**AGENDA FOR THE REGULAR MEETING OF THE
MIDWEST CITY**

PLANNING COMMISSION
September 7, 2021 – 6:00 p.m.
City Council Chambers
City Hall
100 North Midwest Boulevard

Subject: (PC – 2089) Discussion and consideration of adoption, including any possible amendment of the proposed Madison Addition Preliminary Plat, described as a part of the NW/4 of Section 1, T11N, R2W, located at 500 and 600 Davidson Road and 527 and 531 Saint Paul Avenue.

DRAINAGE LOCATION MAP FOR PC-2089 (N/2, Sec. 1, T11N, R2W)

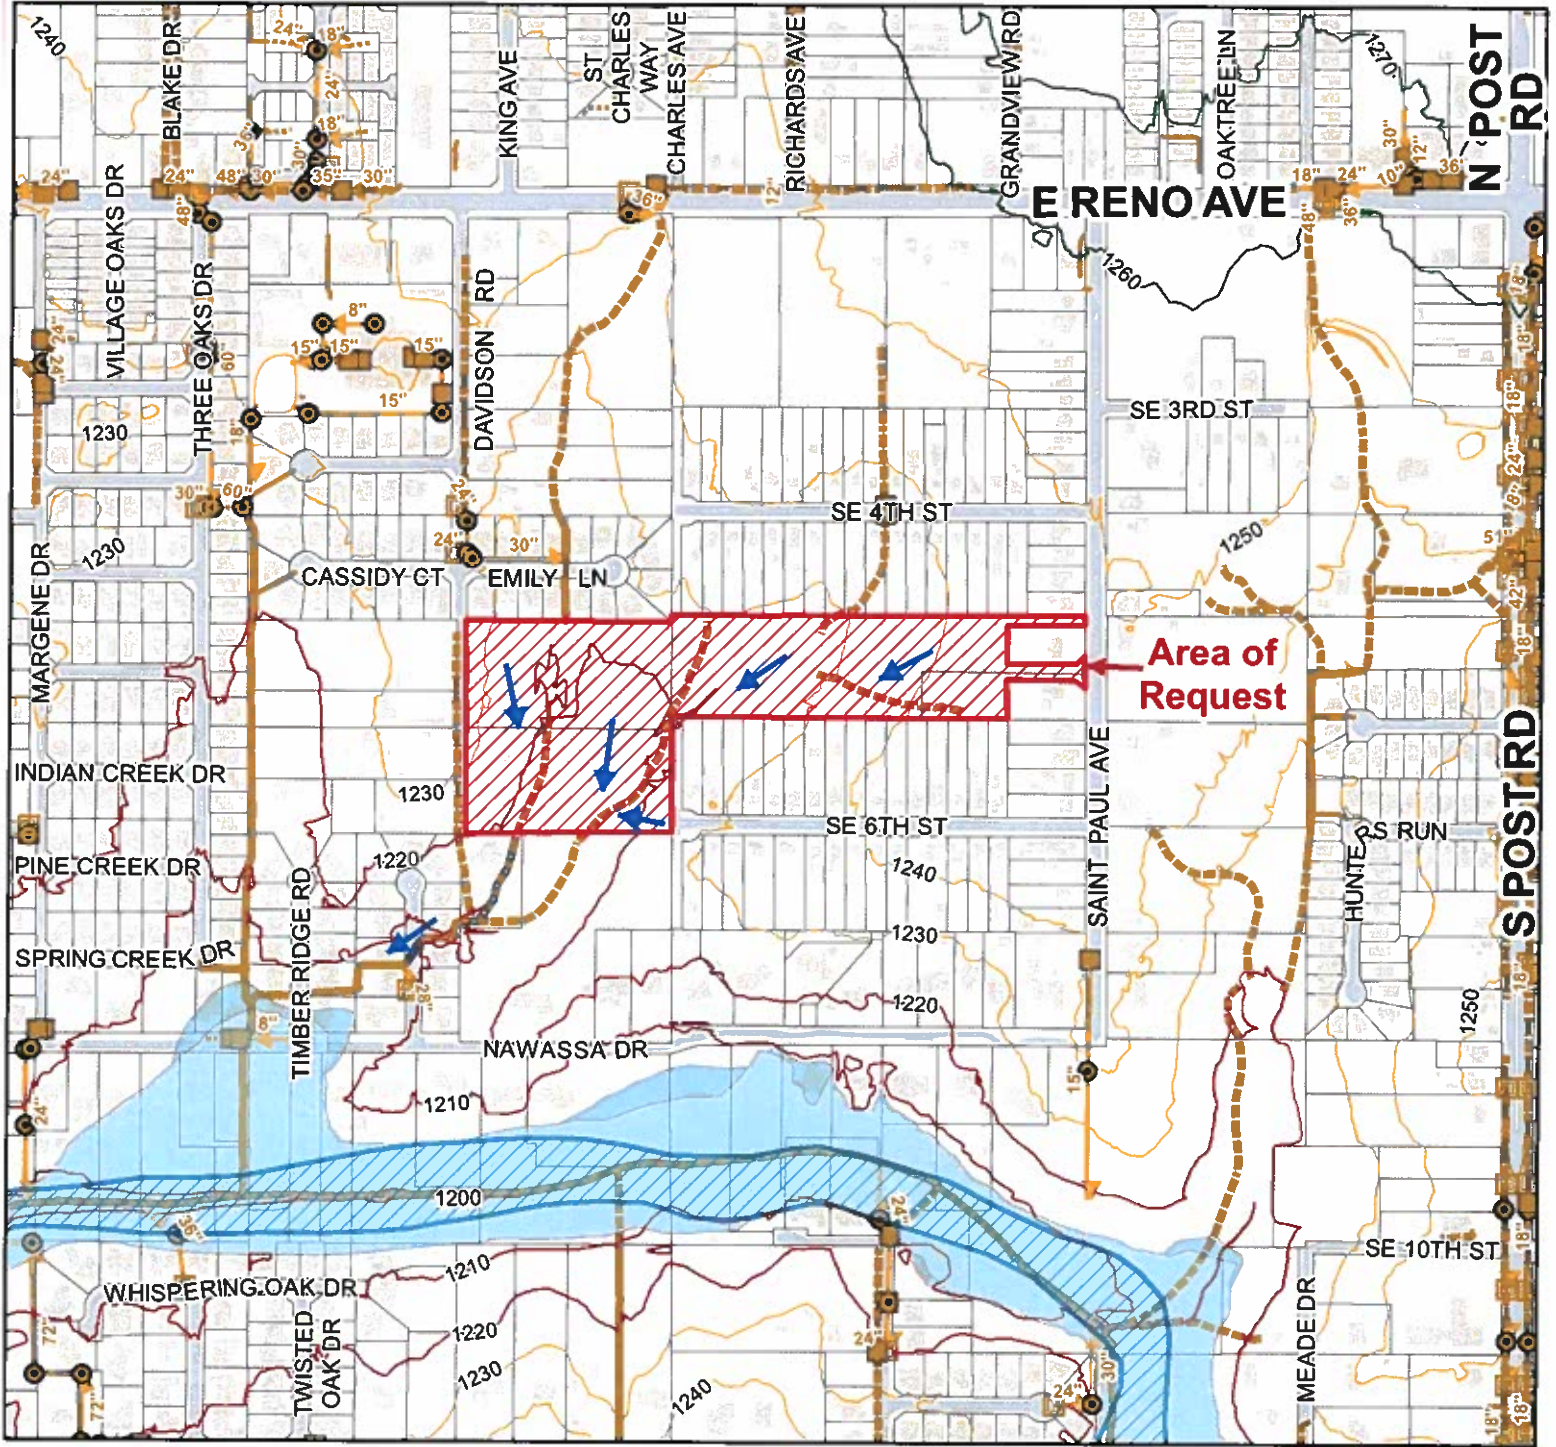
- An unimproved channel flows out of the Kanaly's Homeland 2nd Addition. This channel then flows into the eastern pond.
- Sheet flow runs across the eastern side of the proposed development and parts of the neighboring development to the south, eventually flowing into the eastern pond.

- Water collects off the western end of SE 6th and flows into the proposed development.
- Sheet flow comprises of the rest of the drainage both into and out of the proposed development.

PRELIMINARY SITE DEVELOPMENT PLAN

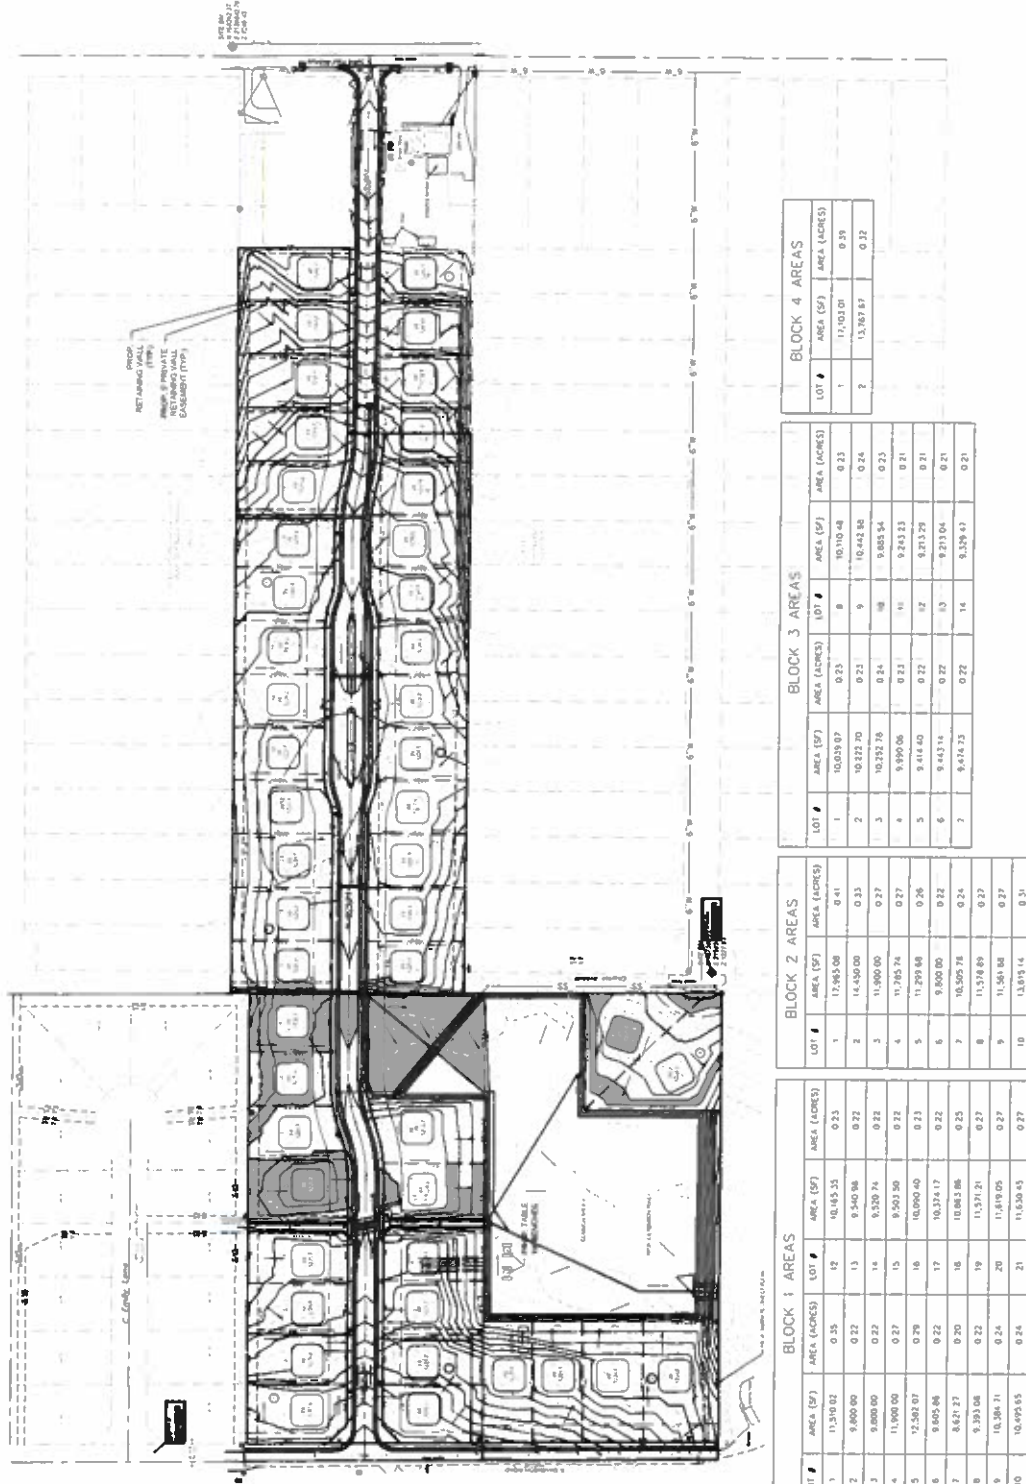
Section 38-18 in the Subdivision Regulations requires all existing and proposed utility lines and public improvements be reflected on the preliminary plat or accompanying plan. The proposed public utility line installations required with this application are shown on the plat, must be constructed and will be dedicated to the city prior to the final plat application.

The applicant has proposed extending the existing eight (8) inch public water main to the southern end of Davidson and carrying across an eight (8) inch public water main to tie into the main on Saint Paul Road. The block 4 lots off SE 6th Street will require extension of the existing six (6) inch public water main. According to the utility plan, all proposed lots would have access to public water as required in Municipal Code 43-32. The lines will be within the proposed right of way of the proposed streets. Connection to the public water supply system for domestic service is a building permit requirement per Municipal Code 43-32 for all new buildings.

Davidson Road is listed as a local road in the 2008 Comprehensive Plan. A right-of-way of 50 feet is required, 25 feet on each side of centerline with an additional ten (10) foot utility easement adjacent to the proposed development. It will be required to be dedicated on the final plat if not already existing.

Saint Paul Road is listed as an existing collector in the 2008 Comprehensive Plan. A right-of-way of 60 feet is required, 30 feet on each side of centerline with an additional ten (10) foot utility easement adjacent to the proposed development. It will be required to be dedicated on the final plat if not already existing.

Improvement plans for the street and sidewalks must be prepared by a registered professional engineer and be submitted to staff for plan review and approval.

The comprehensive plan dictates the connection of internal streets within the square mile sections that are designated as future collector roads. The thoroughfare plan does not designate this area to contain a future collector road. The subdivision plan also requires the connection of roads in a proposed subdivision if the proposal contains fifty or more proposed lots. This application has 48 lots but would meet the requirement with the proposed connections to St. Paul Road and Davidson Road.

Previously, a similar development of the same name was approved by Council in 2020. At that time staff had a third party engineer review the drainage plan and found it satisfactory. The current proposed development does not differ much from the previously approved plan so a third party review was not required for the preliminary plat. However, the same third party engineer will be utilized to review and examine the construction plans if this preliminary plat is approved.

One new curb-cut along Davidson Road and one new curb-cut along Saint Paul will provide access to the area of request.

Section 38-53.4 of the 2012 Midwest City Subdivision Regulations requires the applicant to submit a Tree Canopy Management Plan with the preliminary plat application. The applicant has submitted a Tree Canopy Management Plan as well as a partial waiver request to this requirement. The waiver is included in this agenda packet. The applicant has provided a Tree Canopy Management Plan showing the tree canopy he intends to leave throughout the platting process. The waiver would allow the applicant to remove all trees outside of the area designated as common area.

It should be noted that several lots back onto the area that is to be dedicated as park land. The Subdivision Regulations states that lots should not back onto park land. The applicant modified the design of this subdivision from what was approved in May 2020 to work better with the existing topography and the cost of fill. The applicant has stated that, if approved, he will include in the covenants a provision that those lots backing to the park land must have black chain-link fence to allow for visibility and a more welcoming area. It should also be noted that the park land, as approved by the Park Land Review Committee will be private and only accessible to the homeowners of the subdivision, not the public.
